Going-to-the-Sun Road
Identified Roadway Deficiencies - 2001

Going-to-the-Sun Road
Identified Roadway Deficiencies - 2001
Alpine Section
Alder Creek Segment - Map 1 of 3
Guard Walls:
ashlar stone
concrete-core
jersey barrier
removable rail
random rubble stone
mixed stone
Retaining Walls:
concrete
stone
Other Linear Features:
barrier rock
curb
post and rail fence
CMP culvert with stone headwall
concrete-box cross-road drains with metal grate inlet
CMP culvert
CMP culvert with stone headwall
CMP culvert with modern drop box inlet
CMP culvert with stone headwall
CMP culvert with stone headwall
drop inlet covered with boards
FHWA wall 25.01
FHWA wall 25.29
FHWA wall 25.32
FHWA wall 25.33
FHWA wall 25.34
FHWA wall 25.36
FHWA wall 22.82
pullout
pullout
pullout
MP 23.0
MP 23.1
MP 25.3
MP 25.4
MP 25.5
MP 25.6
MP 25.7
919
917
916
915
914
913
912
911
910
909
908
906
905
904
903
MP 25.3 - 25.5:

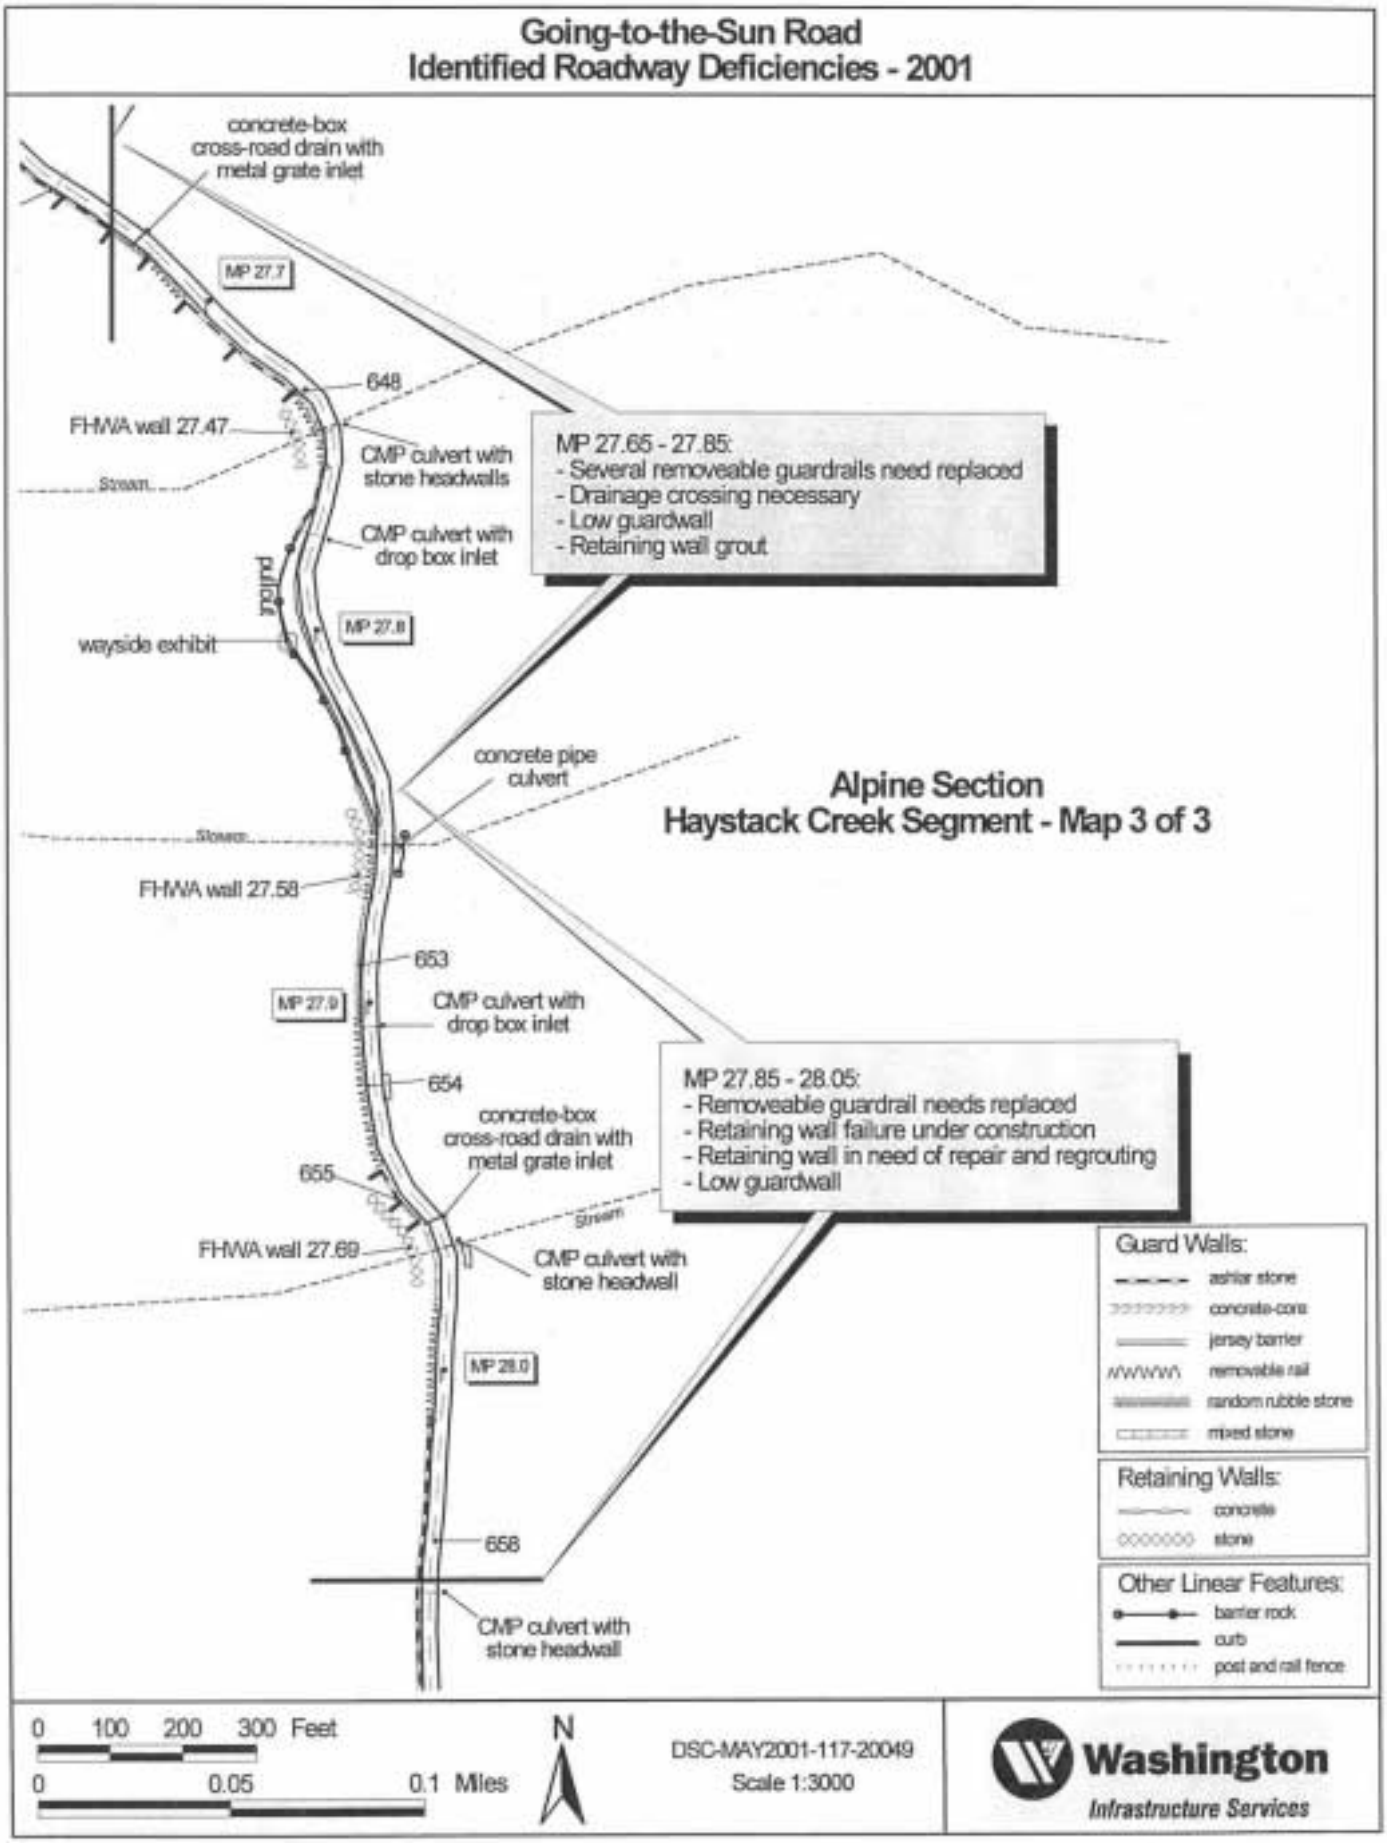
- Several removeable guardrails need replaced
- Drainage crossing necessary
- Low guardwall
- Retaining wall grout
concrete pipe culvert
Alpine Section
Haystack Creek Segment - Map 3 of 3
Stream
FHWA wall 27.58
653
MP 27.9
CMP culvert with drop box inlet
654
concrete-box cross-road drain with metal grate inlet
655
MP 27.85 - 28.05:

- Removeable guardrail needs replaced
- Retaining wall failure under construction
- Retaining wall in need of repair and regrouting
- Low guardwall
Stream
FHWA wall 27.69
CMP culvert with stone headwall
MP 28.0
658
CMP culvert with stone headwall
Guard Walls:
ashlar stone
concrete-core
jersey barrier
removable rail
random rubble stone
mixed stone
Retaining Walls:
concrete
stone
Other Linear Features:
barrier rock
curb
post and rail fence
0 100 200 300 Feet
0 0.05 0.1 Miles
N
DSC-MAY2001-117-20049
Scale 1:3000
Washington
Infrastructure Services

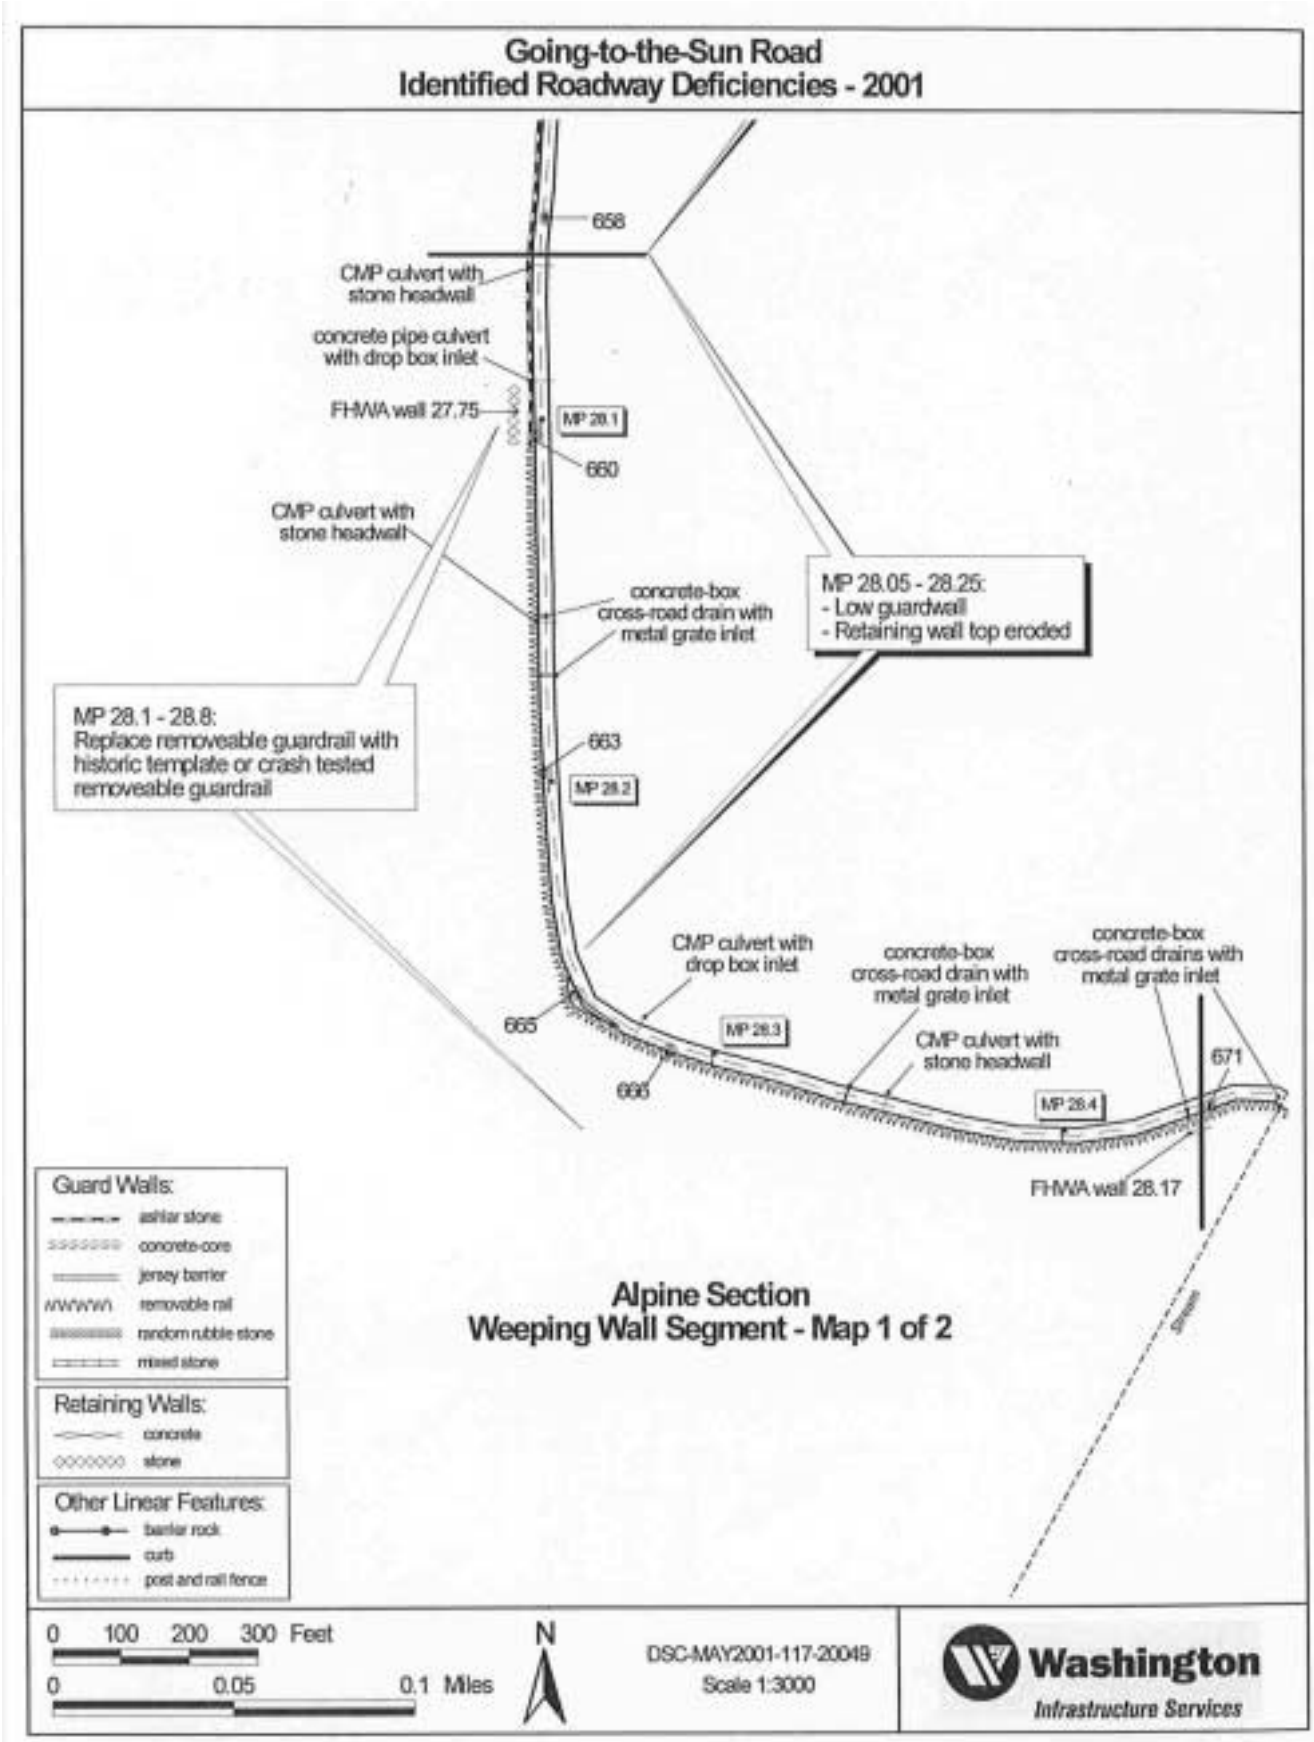
- Low guardwall
- Retaining wall top eroded
MP 28.1 - 28.8:
Replace removeable guardrail with historic template or crash tested removeable guardrail
663
MP 28.2
CMP culvert with drop box inlet
concrete-box cross-road drain with metal grate inlet
concrete-box cross-road drains with metal grate inlet
665
MP 28.3
CMP culvert with stone headwall
671
666
MP 28.4
FHWA wall 28.17
Guard Walls:
ashlar stone
concrete-core
jersey barrier
removable rail
random rubble stone
mixed stone
Retaining Walls:
concrete
stone
Other Linear Features:
barrier rock
curb
post and rail fence
Alpine Section
Weeping Wall Segment - Map 1 of 2
0 100 200 300 Feet
0 0.05 0.1 Miles
N
DSC-MAY2001-117-20049
Scale 1:3000
Washington
Infrastructure Services

Going-to-the-Sun Road
Identified Roadway Deficiencies - 2001
Alpine Section
Big Bend Segment - Map 1 of 3
MP 28.8 - 29.0:
- Water damaged concrete pavement and gutter

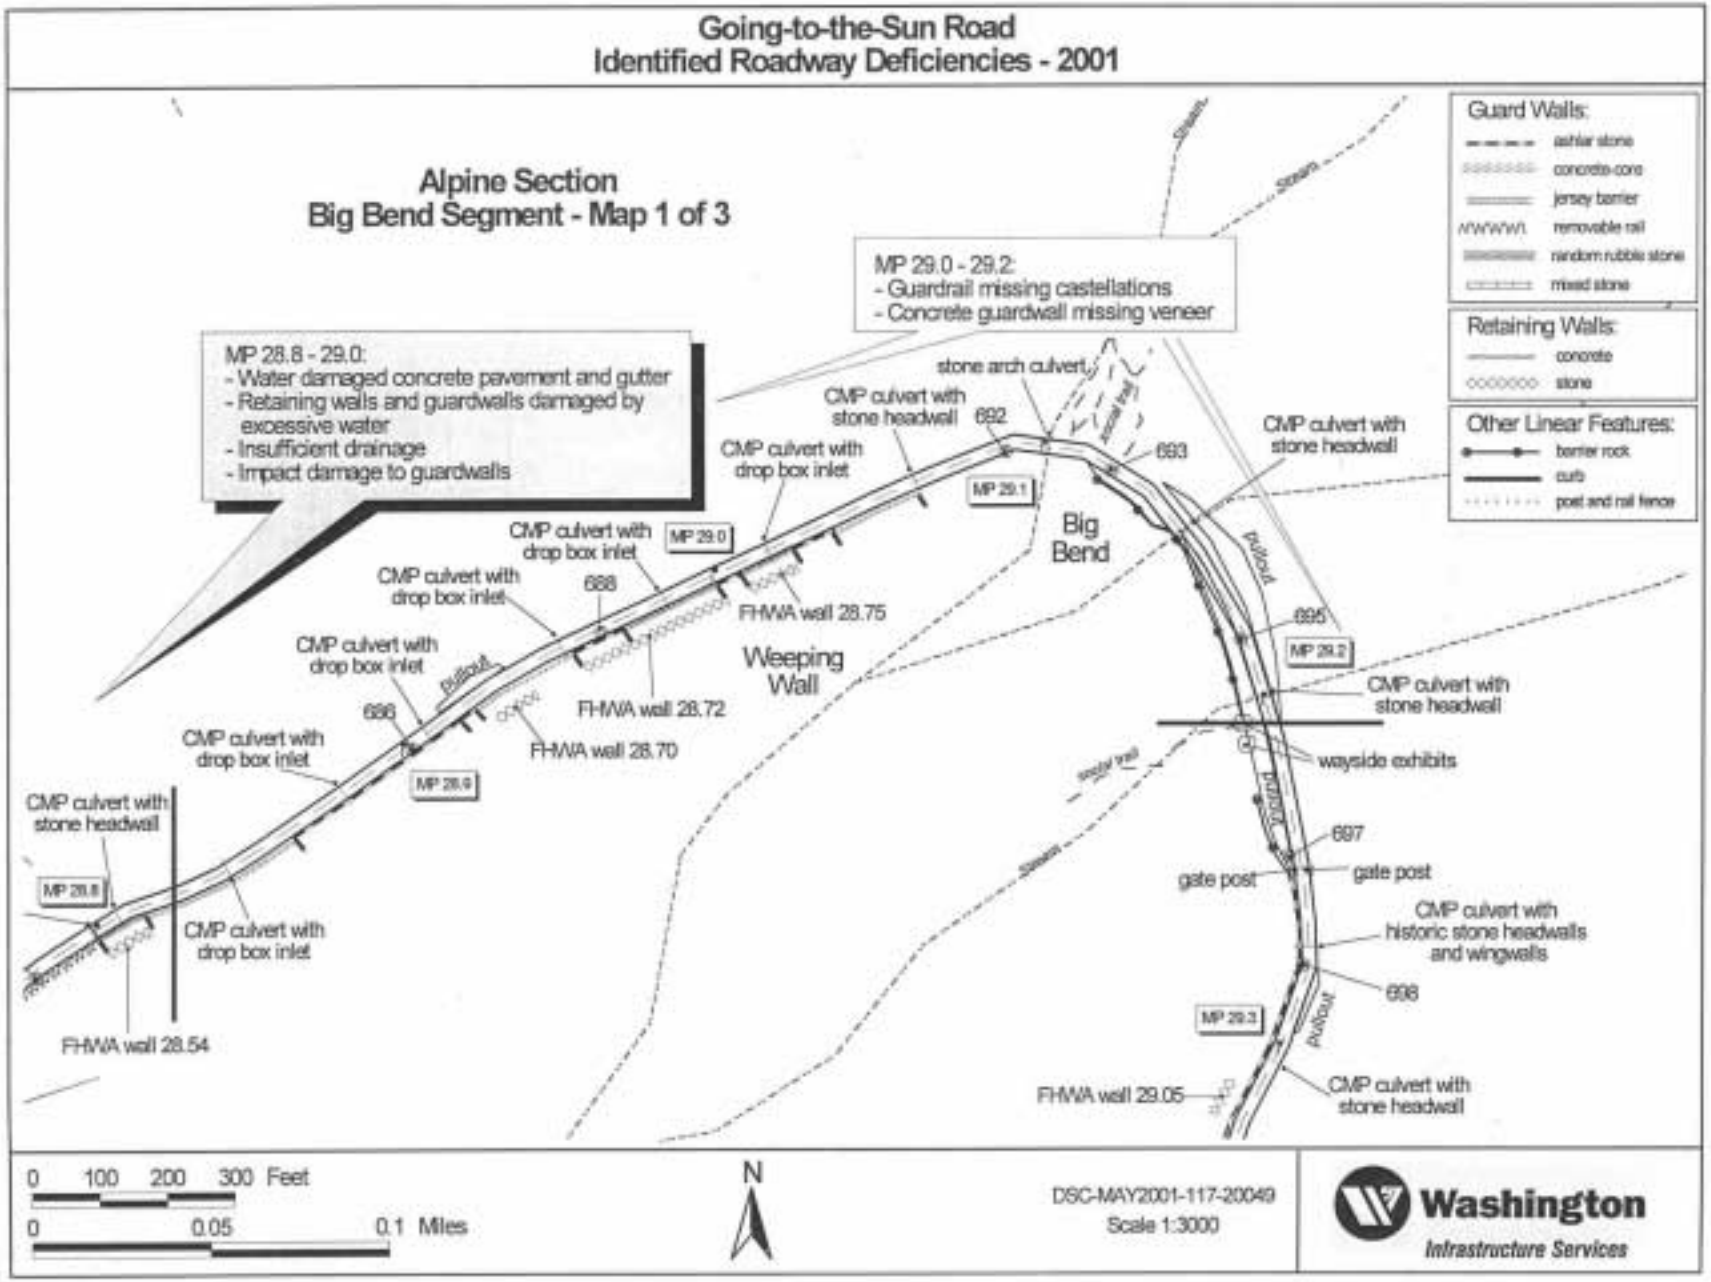
- Retaining walls and guardwalls damaged by excessive water
- Insufficient drainage
- Impact damage to guardwalls
MP 29.0 - 29.2:
- Guardrail missing castellations

- Concrete guardwall missing veneer
Guard Walls:
ashlar stone
concrete-core
jersey barrier
removable rail
random rubble stone
mixed stone
Retaining Walls:
concrete
stone
Other Linear Features:
barrier rock
curb
post and rail fence
CMP culvert with stone headwall
CMP culvert with drop box inlet
stone arch culvert
692
693
695
696
697
698
688
MP 28.8
MP 28.9
MP 29.0
MP 29.1
MP 29.2
MP 29.3
Big Bend
Weeping Wall
FHWA wall 28.54
FHWA wall 28.70
FHWA wall 28.72
FHWA wall 28.75
FHWA wall 29.05
wayside exhibits
gate post
CMP culvert with historic stone headwalls and wingwalls
Stream
Pullout
0 100 200 300 Feet
0 0.05 0.1 Miles
N
DSC-MAY2001-117-20049
Scale 1:3000
Washington
Infrastructure Services

- Dry stack retaining wall severely deteriorated
- Guardwall tipping over
- Drainage inlet unprotected
Alpine Section
Big Bend Segment - Map 2 of 3
702
MP 29.4
CMP culvert with stone headwall and wingwalls
CMP culvert with stone headwall
705
MP 29.5
706
MP 29.4 - 29.6:

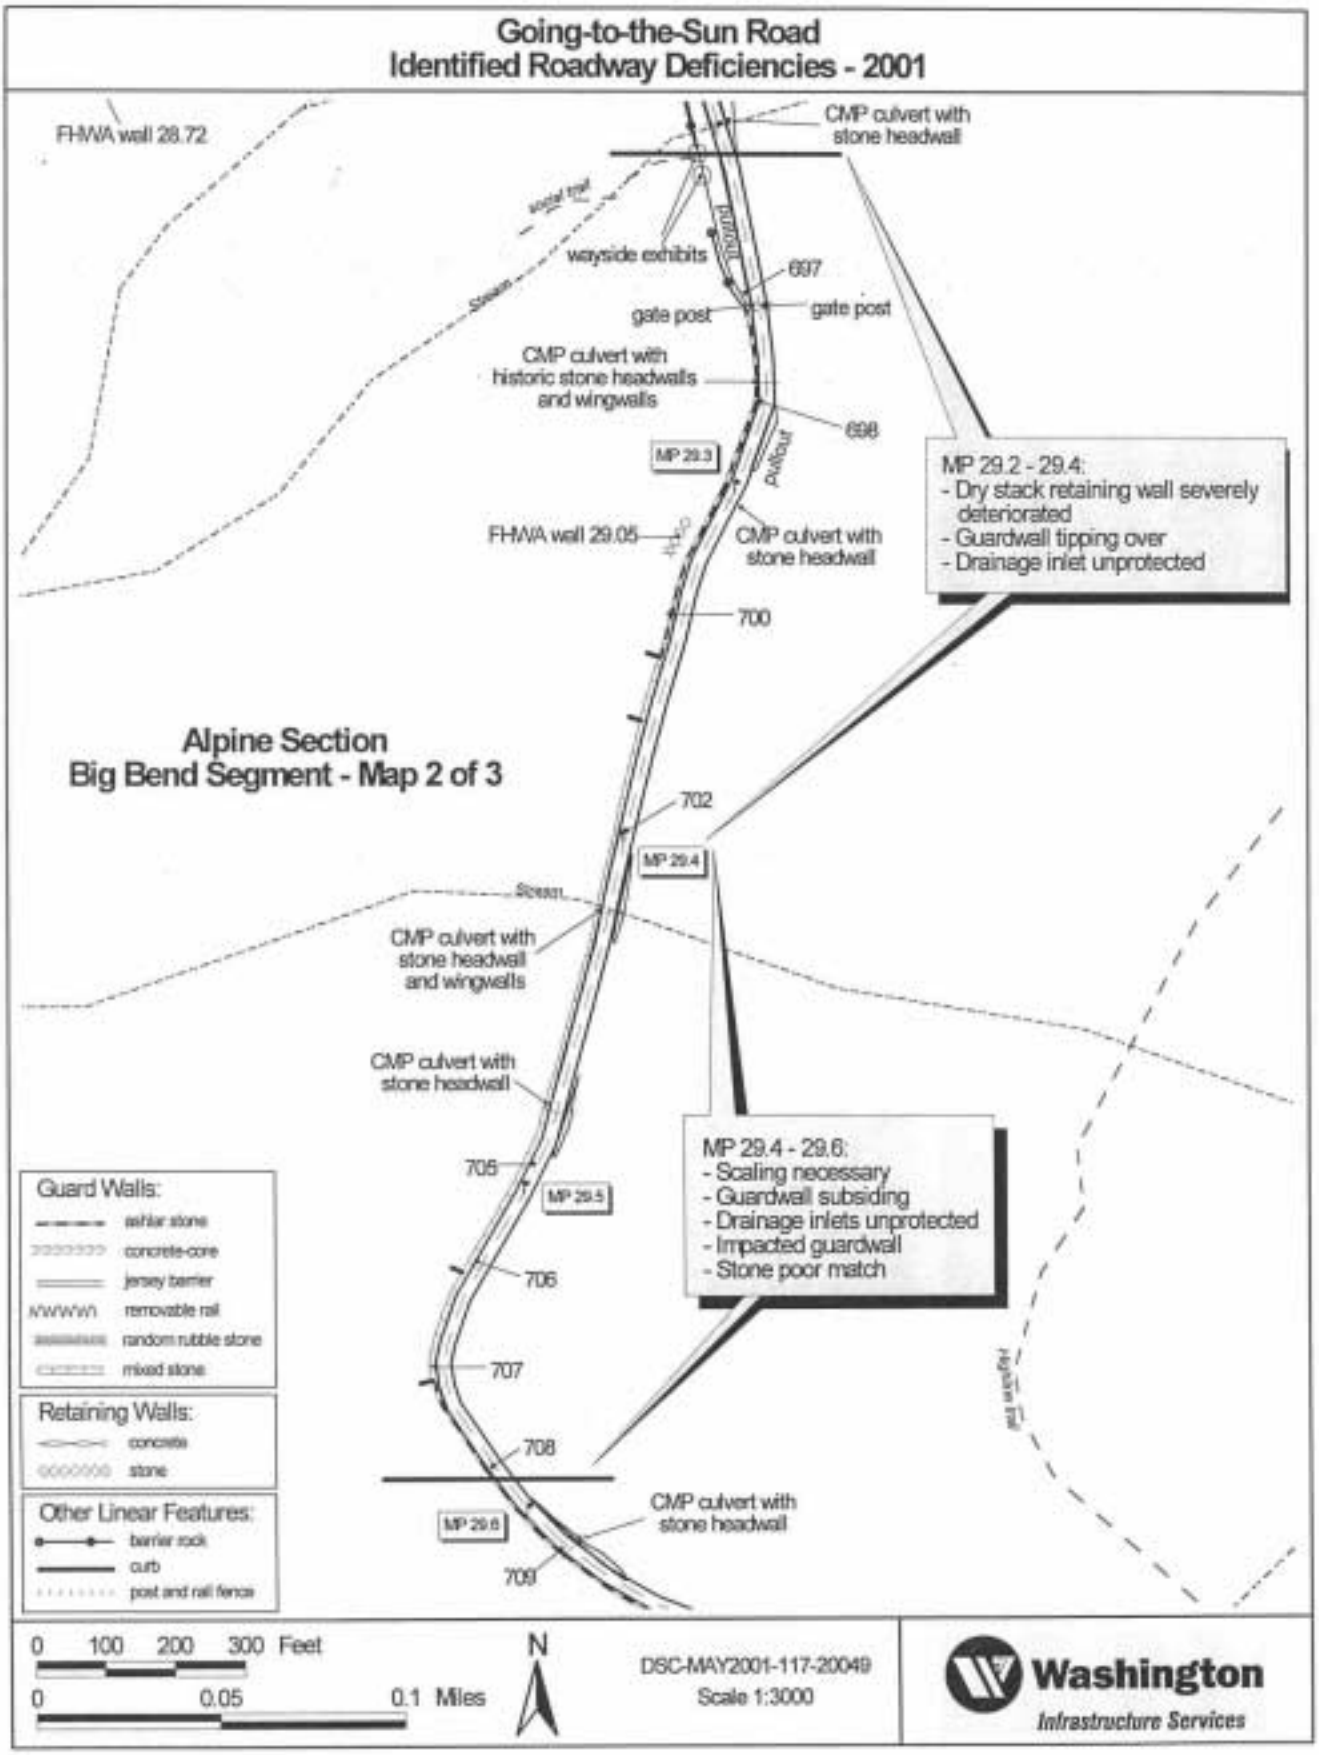
- Scaling necessary
- Guardwall subsiding
- Drainage inlets unprotected
- Impacted guardwall
- Stone poor match
707
708
MP 29.6
CMP culvert with stone headwall
709
Guard Walls:
ashlar stone
concrete-core
jersey barrier
removable rail
random rubble stone
mixed stone
Retaining Walls:
concrete
stone
Other Linear Features:
barrier rock
curb
post and rail fence
0 100 200 300 Feet
0 0.05 0.1 Miles
N
DSC-MAY2001-117-20049
Scale 1:3000
Washington
Infrastructure Services
